# **Rezoning Transportation Analysis**

Petition Number: #2022-107
General Location Identifier: 08119159

Date	Description		
11-28-22	First Review (IW)		
12-22-22	Second Review (DR)		
01-26-23	Third Review (IW)		
03-22-23	Fourth Review (IW)

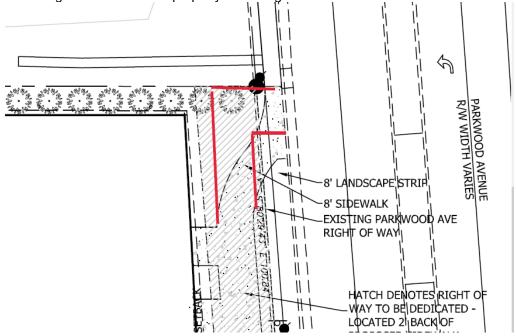
TREE TO REMAIN - END OF SIDEWALK MIMOSA AVENUE

CONNect sidewalks

AT D A CONNECT SIDEWALK MIMOSA AVENUE

Clarifying comment from 12/22/2022: Commit to connect sidewalk near single family structure to existing sidewalk on Mimosa Avenue as shown above.

Clarifying comment from 12/22/2022: Extend 8-foot sidewalk as shown above to property line along Parkwood Avenue.
